Interactive comment on “Lumped convolution integral models revisited: on the meaningfulness of inter catchment comparisons” by S. Seeger and M. Weiler

S. Seeger and M. Weiler

Received and published: 18 August 2014

Fig. 1.

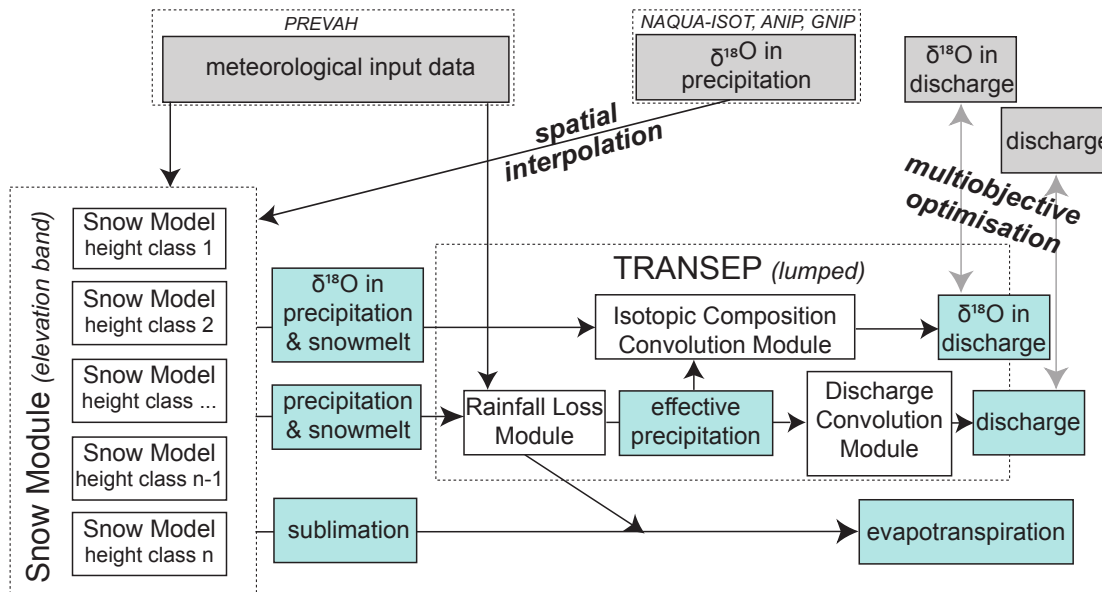
- Fig. 2: Maybe the authors can find a way to convey the information with a simpler scheme. E.g. I would use only one arrow connecting the box "input variables from PREVAH" to the box "snow module".

Thanks to this comment, we realised that the explicit depiction of the five meteorological input variables does not help to convey the essential information and we merged them into one box (see first appended Figure). Apart from that, we would refrain from further simplifications of the model scheme.

Fig. 2.

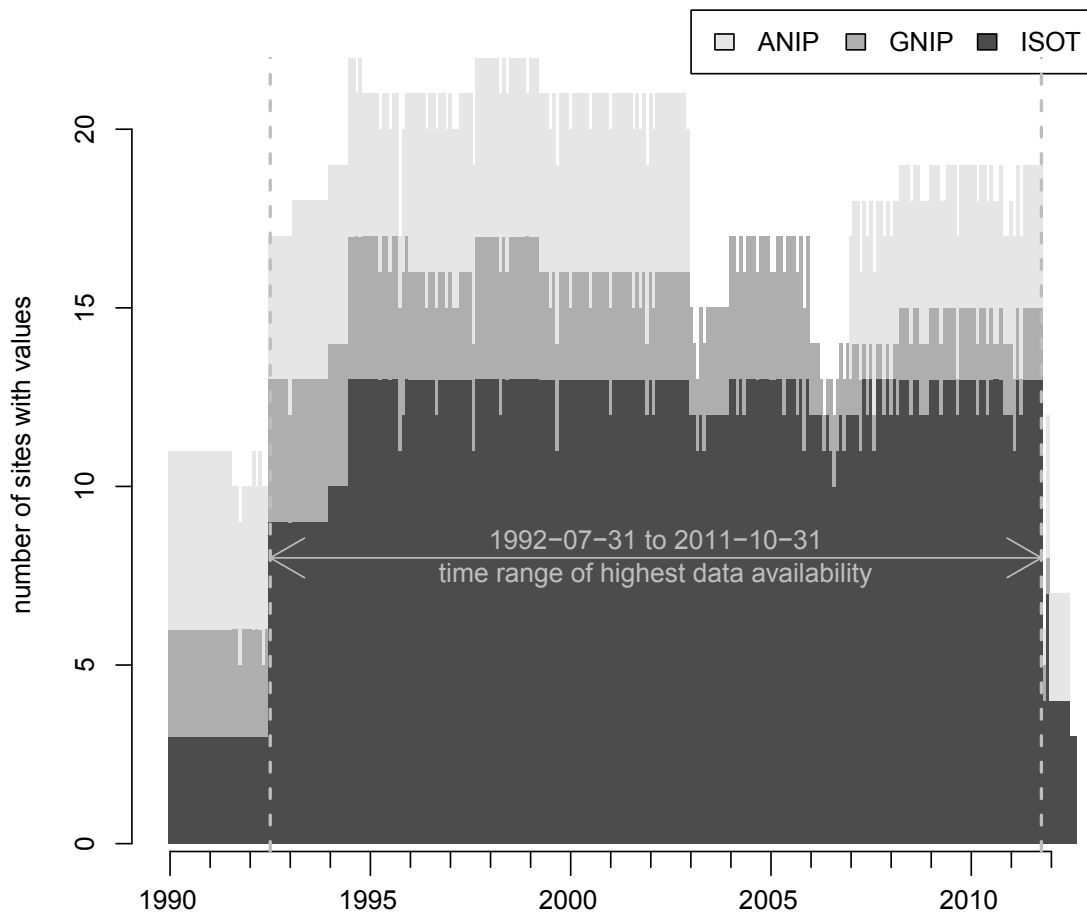
- Page 6761, Eq. 5: It is not clear to me why only $\overline{i_s}$ was interpolated and not i_s . If both were interpolated, there would be no need of identifying the closest measurement point s^* .

Our input time series of isotopes in precipitation exhibit various gaps (see the attached Fig. 2 of this reply). In months with few available site data, a direct interpolation of the available monthly site data will inevitably fail to reproduce the real spatial heterogeneity. By basing the estimation on average monthly values, we may retain at least the average component of spatial heterogeneity.
